DU MONT

SERVICE NOTES

RA-103D-104A-110A

PRODUCTION CHANGES

Figure 1

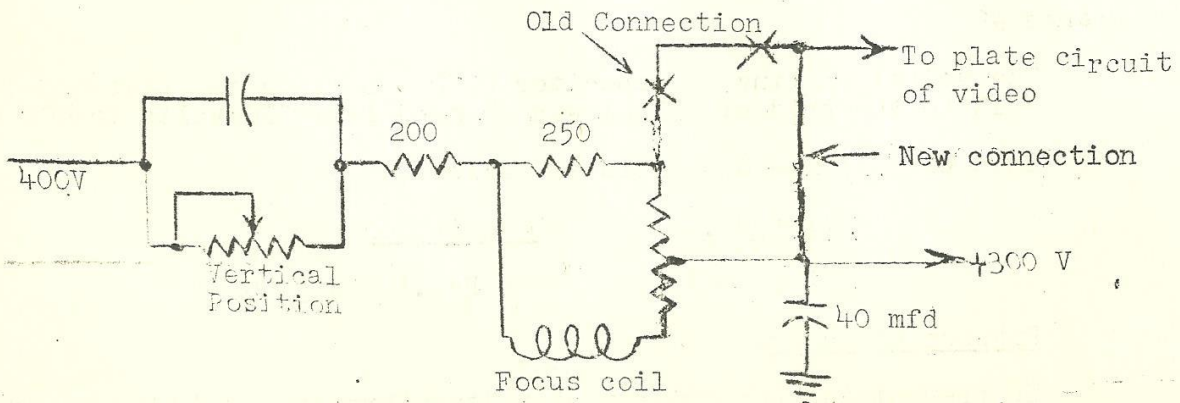
1. In the early models, the plate circuit of V205, the video amplifier, was connected to the junction of R286B and the focus control. With this wiring arrangement, the only time the B+ line going to the video amplifier was completely by-passed by C264B, was when the focus control was at its extreme clockwise position.

In order that this line be adequately by-passed at all times, the B+ line to the video amplifier is now connected to the arm of the focus control. This change is shown in Fig. 1.

This change reduces the B+ voltage of the video amplifier about 25 to 30 volts but does not noticeably affect the operation of this stage.

Figure 2

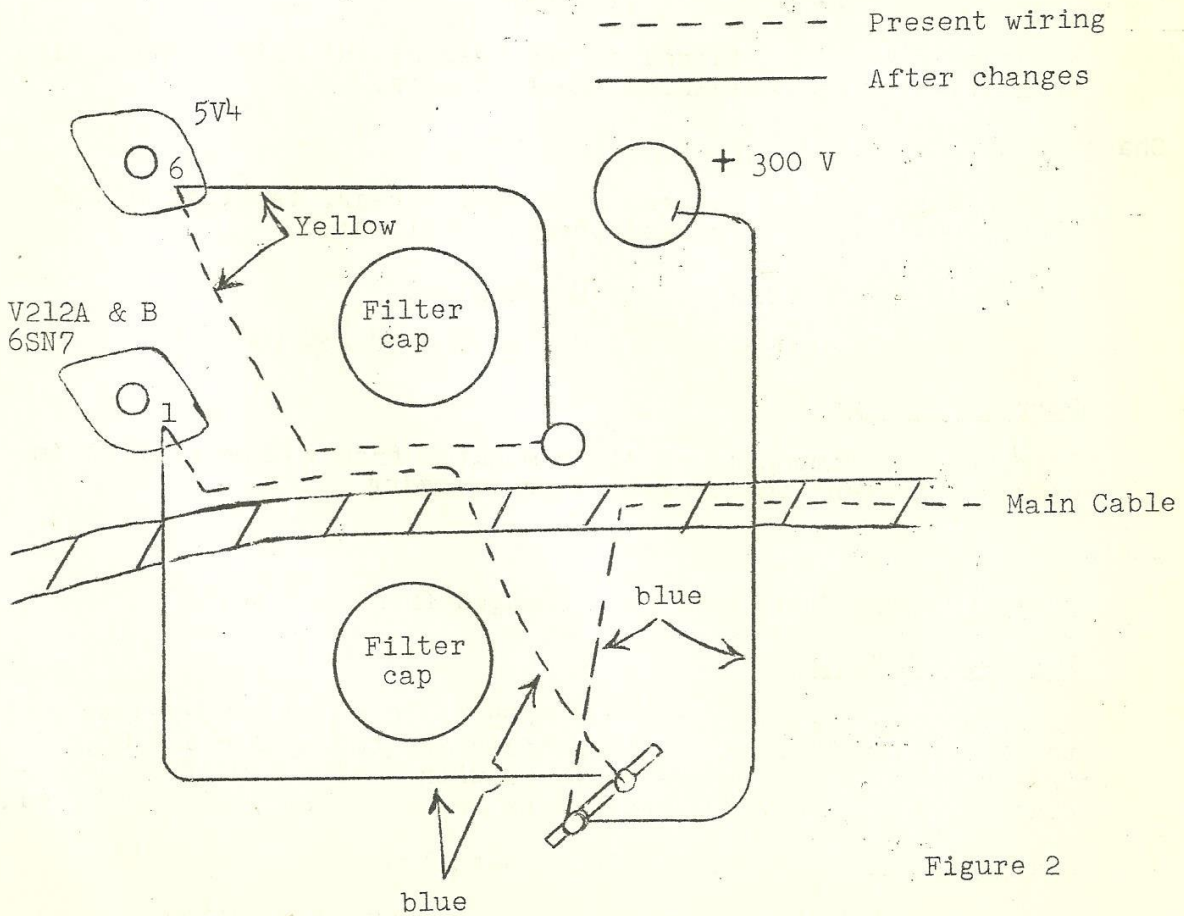
2. In addition to the above wiring change, it was necessary to redress certain leads to eliminate pick up in the sync circuits. The proper lead dress is described in items (a) and (b) below and illustrated in Figure 2.

(a) The lead from the coupling capacitor (C306) to the grid of the sync clipper (V212A) should not be run under the main cable between the two large filter capacitors. Rather, it should go straight from the terminal board toward the rear of the chassis, and then after a 90° turn, it goes to the grid of V212A so that it passes under the main cable at right angles.

(b) The lead from the high side of the yoke now goes to pin 6 of the 5V4 by running parallel with the main cable through the space between the two large filter capacitors and then to the 5V4. This lead (colored yellow) should go toward the linearity coil after emerging from the grommet and then after a 90° turn to pin 6 of the 5V4.

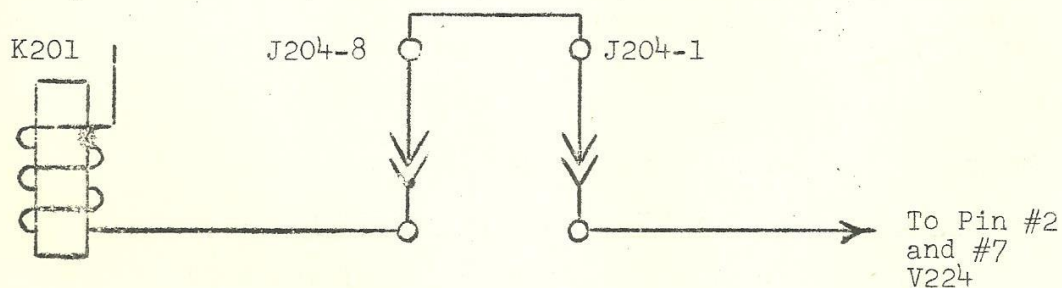
Add symbols and specifications to L221 deflection yoke as follows:

Located between L221-4 and L221-5

R356	02031740	Res F C 560 10% 1/2W
------	----------	----------------------

Located Between L221-5 and L221-6

Figure 1

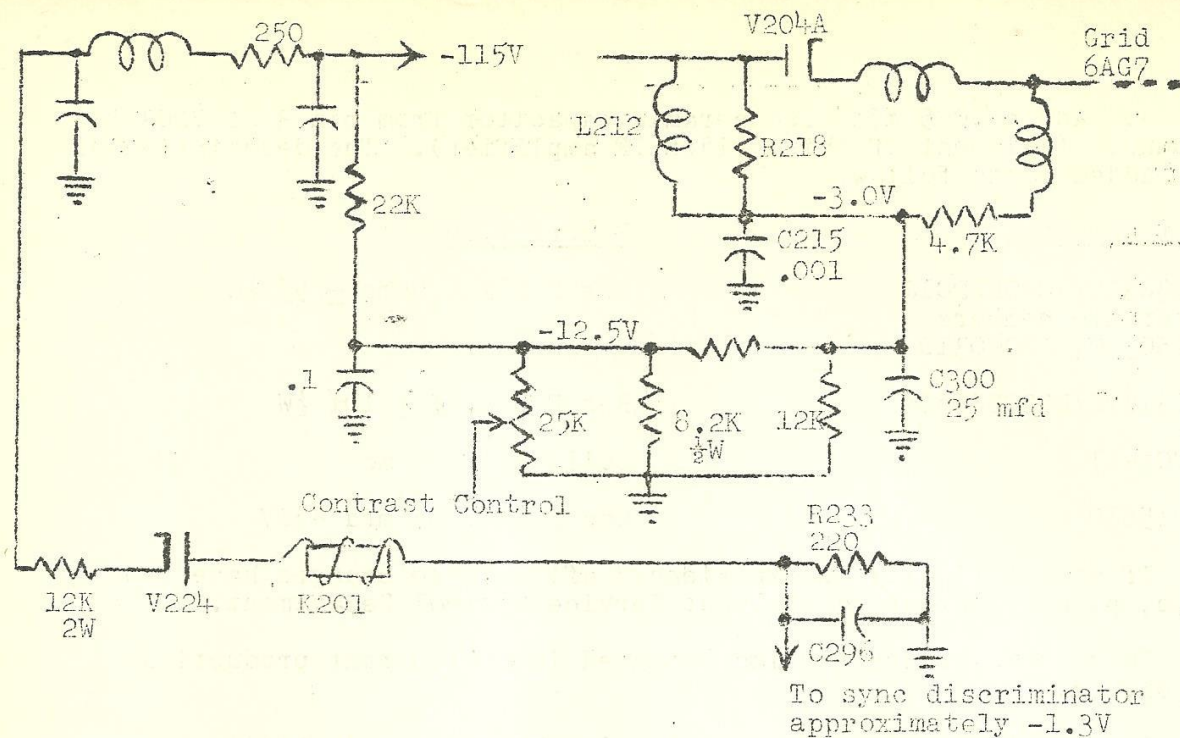
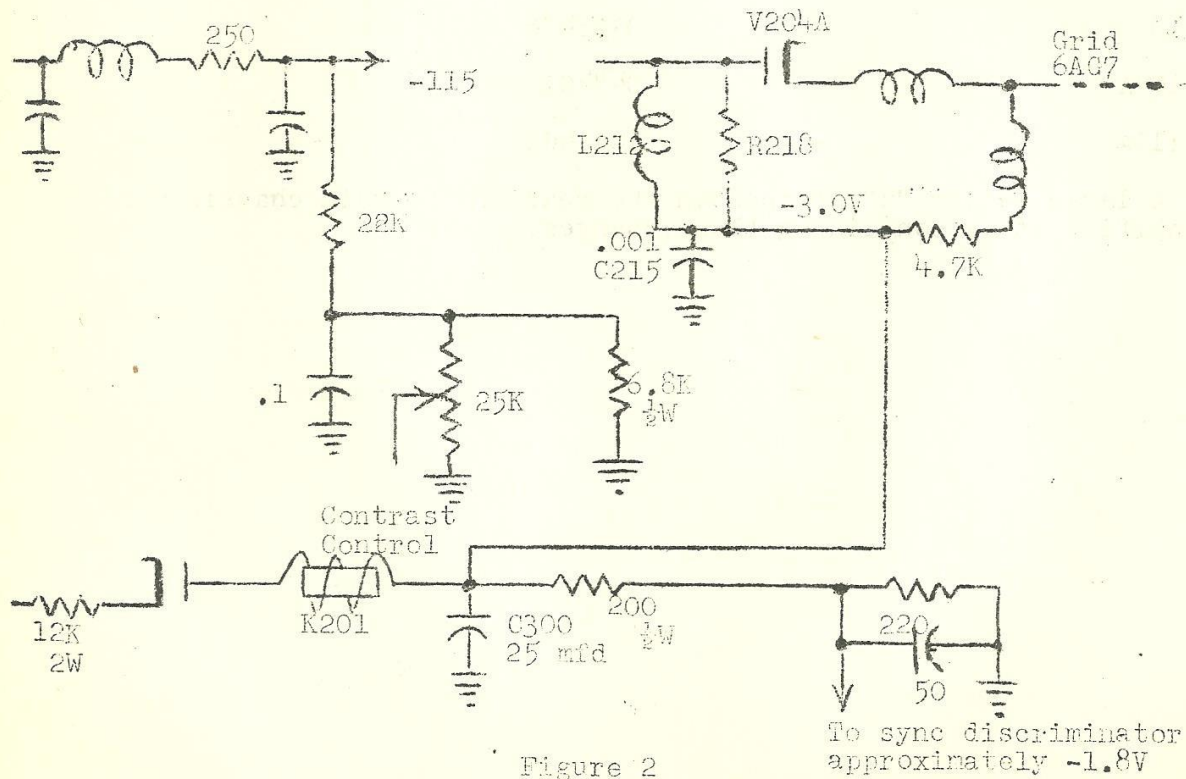
2. Change the bias circuit of the video amplifier V205, from that shown in Fig. 1 to the circuit shown in Fig. 2. In the existing circuit, the bias voltage for the mixer and the video amplifier are taken from the same point. The new bias circuit applies bias to the video amplifier from a different point. The only changes involved follow:

- a. Insert a 200 ohm $\frac{1}{2}$ watt resistor between the relay coil and the junction of R233 and C296.
- b. Remove the connection between C300 and the junction of R337 and R336. Leave C300 connected to the junction of R219, C215, R218 and L212.
- c. Connect the junction of the relay coil and the added 200 ohm resistor to the video amplifier grid circuit at C300.
- d. Remove R216 (8.2K), R336 (27K), and R337 (12K). Add a 6.8K $\frac{1}{2}$ watt resistor as shown in Fig. 3.

Figure 3
Location of Trap

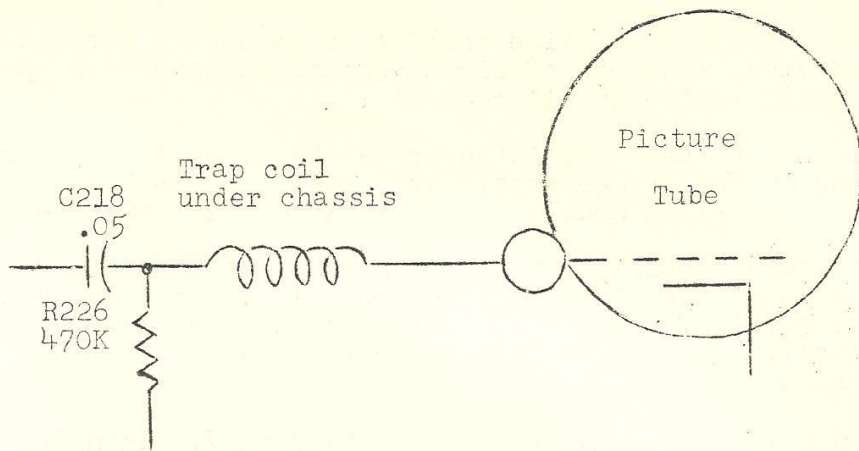
3. Insert a resonant trap coil in series with the CRT grid lead as shown in Figure 3.

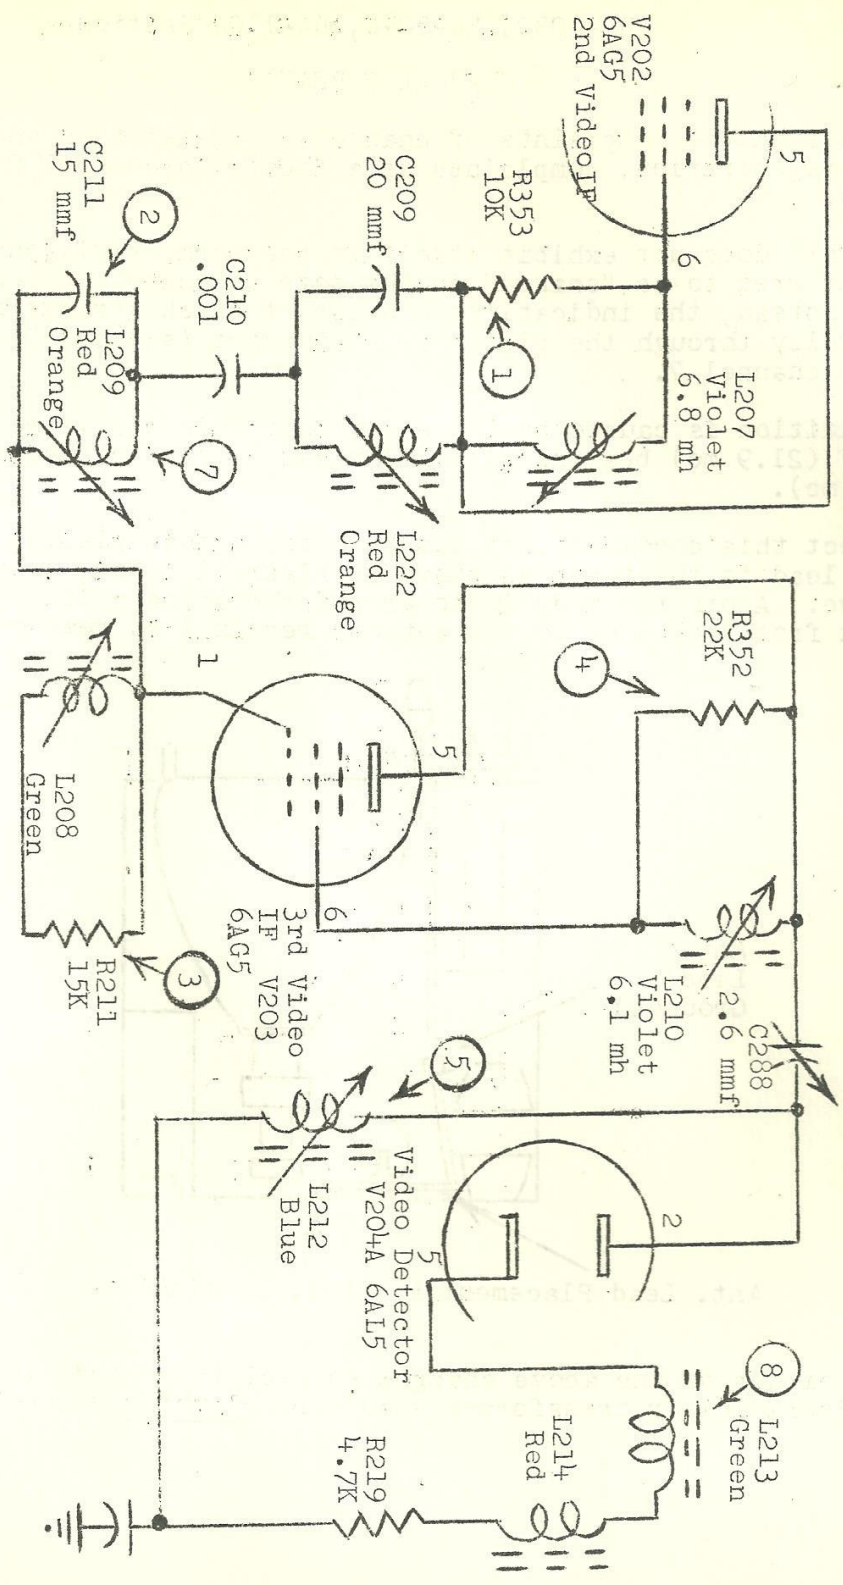
To eliminate this problem, several changes are to be made in the video IF strip and one change in the video amplifier. See Figure 1 for a simplified schematic. Those items affected are indicated by an encircled numeral. The numeral refers to the step to be made in the following procedure.

1. Add a 10K $\frac{1}{2}$ watt 5% resistor across L207. Identify it as R353.
2. Change C211 (connected across L209) from 10 mmf 500V to 15 mmf 500V
3. Change R211 from 3.9K $\frac{1}{2}$ watt to 15K $\frac{1}{2}$ watt.

4. Add a 22K $\frac{1}{2}$ watt 5% resistor across L210. Identify it as R352.
5. Remove R218, the 18K $\frac{1}{2}$ watt resistor connected across L212 in the video detector input circuit. (In earlier sets R218 was 39K and in some of the later sets there are two 39K resistors connected in parallel. See change #7 on page 12a of this section).

6. Add a 22K $\frac{1}{2}$ watt 10% resistor across C217 and L216. (This is the 4.5 mc trap). Identify it as R351. (not shown in Fig.1)
7. Change L209 (color code red white) part number 21004801 to part number 21004802 (color code red orange).

8. Change L213 (color code yellow) part number 21004467 to (color code green) part number 21004464.

In addition to reducing regeneration, these changes will also improve picture quality.

CHANNEL 7 BEAT

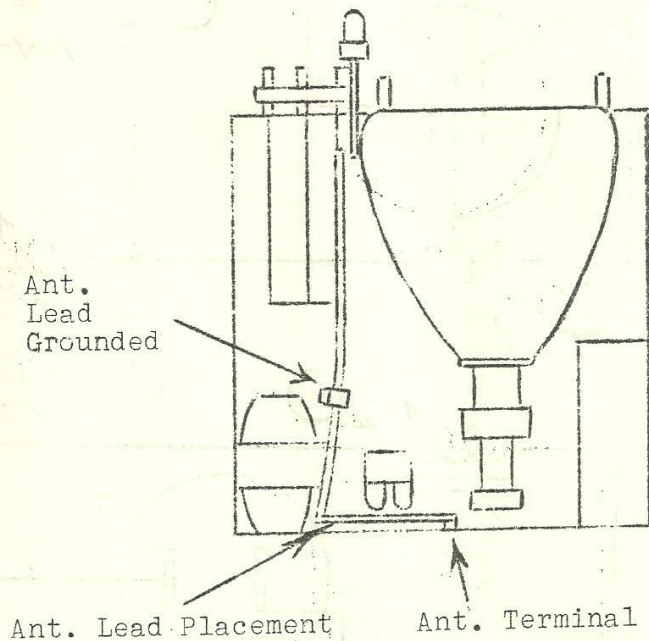
This condition is caused by the eighth harmonic (175.2 mc) of the sound IF (21.9 mc) beating with the video carrier of channel 7 (175.25 mc).

To correct this condition, it has been found that placing the antenna lead to the tuner as shown on Figure 1 below, is very effective. Another remedy is to ground the antenna lead one-half way back from the tuner to the antenna terminal on rear of chassis.

Should neither of the above changes correct this condition, the sound discriminator transformer should be slightly detuned.
